Development Management Highway DC Appeal Statement

APPLICATION NO.	242011
APPEAL REF:	APP/X0360/W/25/3364902
APPEAL SITE:	Land east of Warren Lodge, Warren Lane, Finchampstead, RG40 4HR
PROPOSAL:	Full application for the proposed change of use of land for the siting of 2 no. Gypsy and Traveller pitches with creation of a second access off Finchampstead Road and associated installation of soft and hard landscaping.

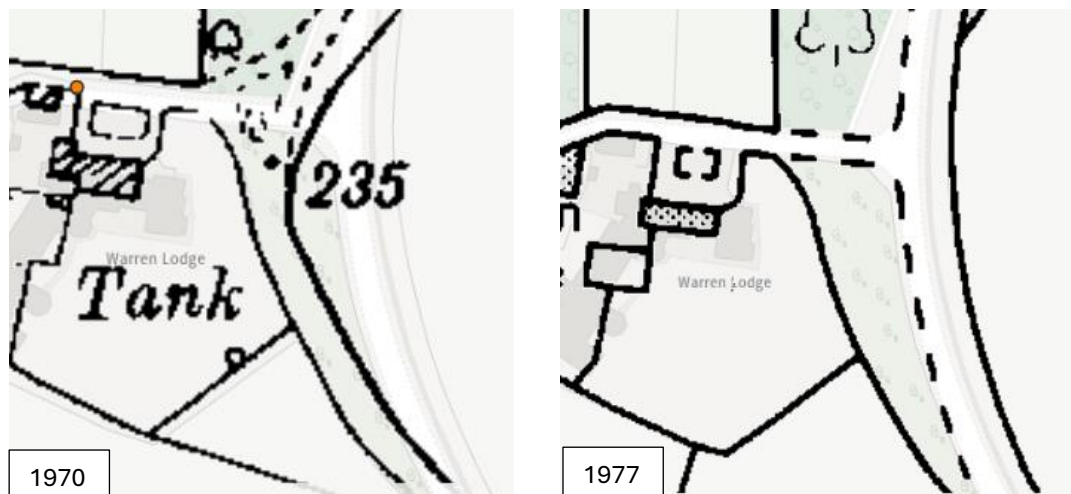
- 3.5. Warren Lane is a bridleway (PRoW Reference: FINC35), with a short section of public highway, depicted below. The public highways end at circa 15m west from the junction of the B3016/Warren Lane (denoted in yellow), and the proposed access falls within the private road section (denoted in pink), where WBC does not own the right of vehicle access at the proposed access point.

- 3.6. The Highways consultation dated 11th October 2024 has required the appellant to demonstrate legal right of access by including all required land to be within the red line and serving notice to relevant landowners on Warren Lane to ensure have control on the land of the private road section of Warren Lane. Failure to demonstrate such rights could result in unlaw use of the proposed access.
- 3.7. The appellant has not addressed this comment during the planning application. While Paragraph 3.73 of the Appellant Statement of Case has mentioned that this appeal seeks to omit the northern access from the proposal and only retain the access point for pedestrian permeability, the submitted site plan, swept paths and landscape plan have not reflect the proposed arrangement mentioned, for the Highways to assess the feasibility for new parking and turning arrangement of the eastern access.

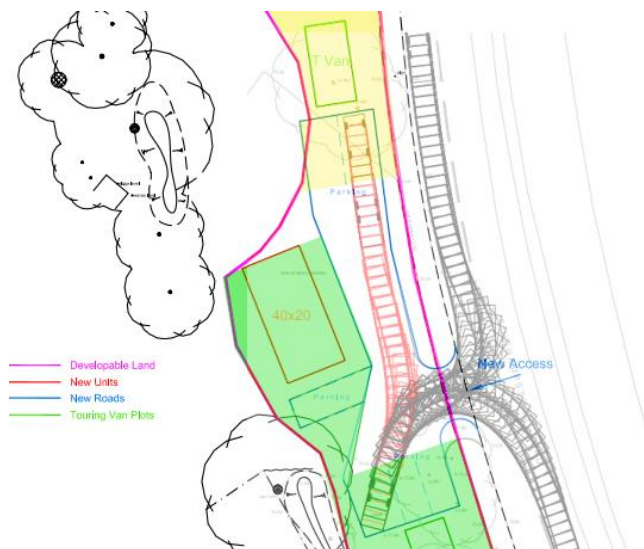
- 4.4. I have considered the application assuming both touring caravans and the six of the car parking spaces to be accessed via the eastern access. Also assuming the areas shaded in yellow would be dedicated to the northern pitch, and those shaded green would belong to the southern pitch. Therefore, vehicles of either pitch will be expected only to utilise its own plot or the shared drive for manoeuvring.

- 4.5. Swept path analysis of a 13m long touring caravan is submitted as Drawing No. TR01. However, for the touring caravan of the northern pitch to enter and leave the site in forward gear, it will encroach into the parking spaces of the southern pitch, as such there can be no certainty this area will be kept clear for manoeuvring as shown below.

- 4.6. The Highway Authority also has concern if the caravan of the northern pitch will be able to manoeuvre in the event the parking space(s) to the south are occupied. Similarly for the southern pitch.

- 4.7. The appellant has been asked to revise the swept path analysis and demonstrate that touring caravan can enter and leave the site in a forward gear, either with the occupation of the proposed parking spaces or a means to control these to ensure the turning manoeuvre can be completed safely off street. However, no revision has been made.

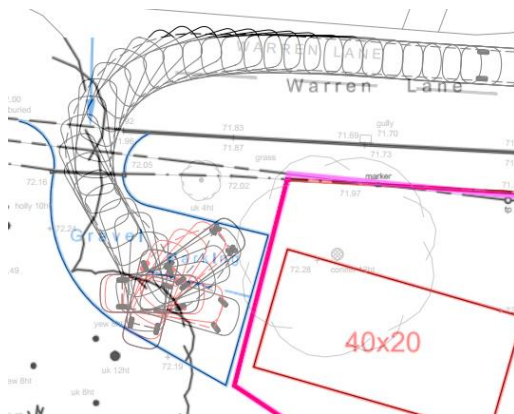
- 4.12. The northern access has been proposed with two driveway parking spaces.
- 4.13. The appellant has demonstrated the swept path of a large saloon car in Drawing No. TR02. I have overlaid the swept path analysis with the proposed parking plan, and it reveals that the car would struggle to park safely in the available space and would require multiple turns to enable it to enter and leave in forward gear.

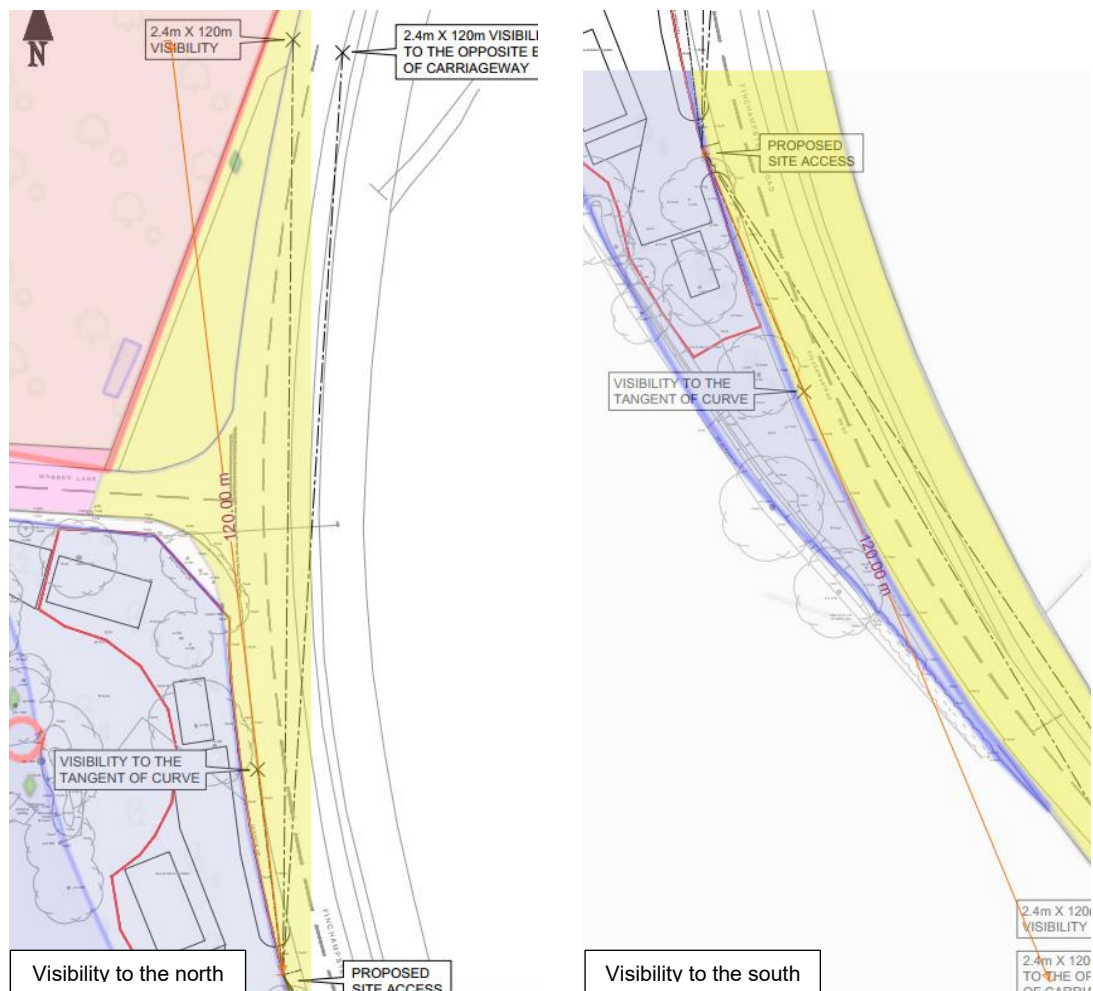
- 4.15. The B3016 Finchampstead Road is subject to a speed limit of 40mph, which requires visibility splays of 2.4m x 120m to be provided from the access onto the B3016 Finchampstead Road. The sightlines shall be across land within the applicant's control or highway land and shall be clear of obstructions to visibility exceeding 0.6m in height.

- 4.16. The appellant has assessed the required visibility splays in Drawing No. 001, whereas the visibilities along the tangent to a bend in both directions has been indicated.

- 4.17. I have cross-examined the site plan with the public highway boundary and the TPO data and confirmed that the tangential visibility in both directions could cover the required 120m SSD on the nearside edge in both directions of carriageway.

- 4.18. To ensure drivers can see approaching vehicles it will be necessary to clear some vegetation along the boundary. Recognising the transient nature of occupations, a planning condition would need to be secured to ensure this remains safe for use at all times. Meanwhile, because this may involve vegetation beyond the property, it may require a highway licence to conduct such maintenance works.

Without Prejudice

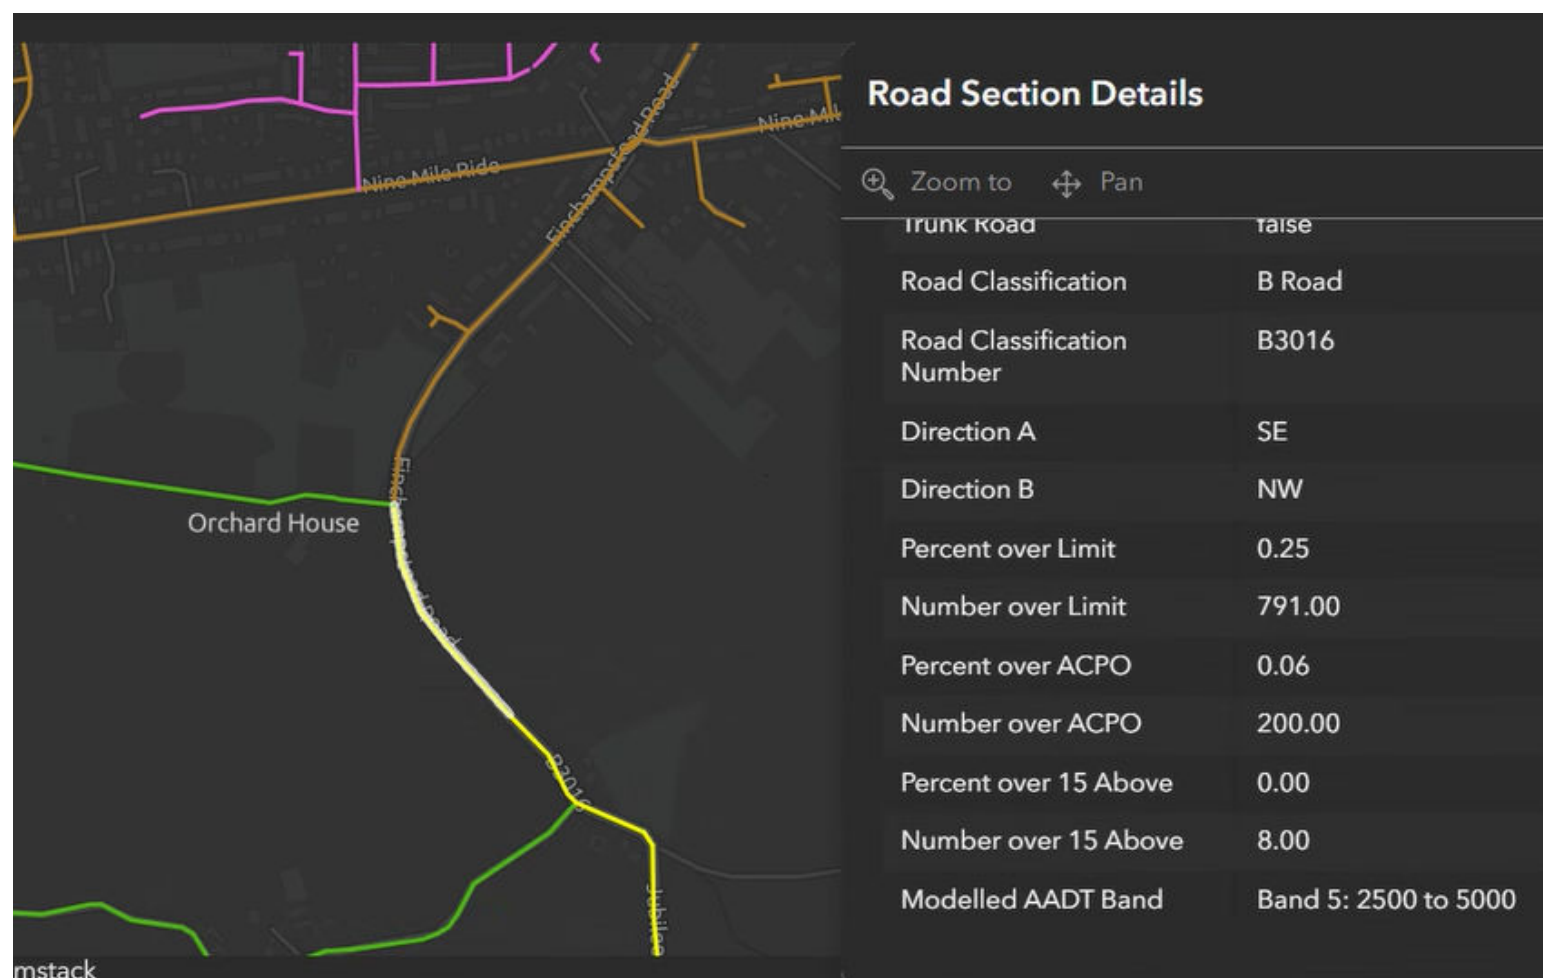
- 5.11. If the Inspector were minded to allow the appeal, I recognise that the development scale is insufficient on its own to justify comprehensive highway mitigation. I do, however, consider the NPPF tests would support a proportion mitigation delivering a pedestrian refuge and connecting footways north of Warren Lane, thereby being directly related and in reasonable scale and kind.
- 5.12. The need for this mitigation would be secured through a S.106 obligation, with the works themselves to be delivered via a S.278 agreement with the highway authority. Such a measure would assist existing and future occupiers access local facilities and services.
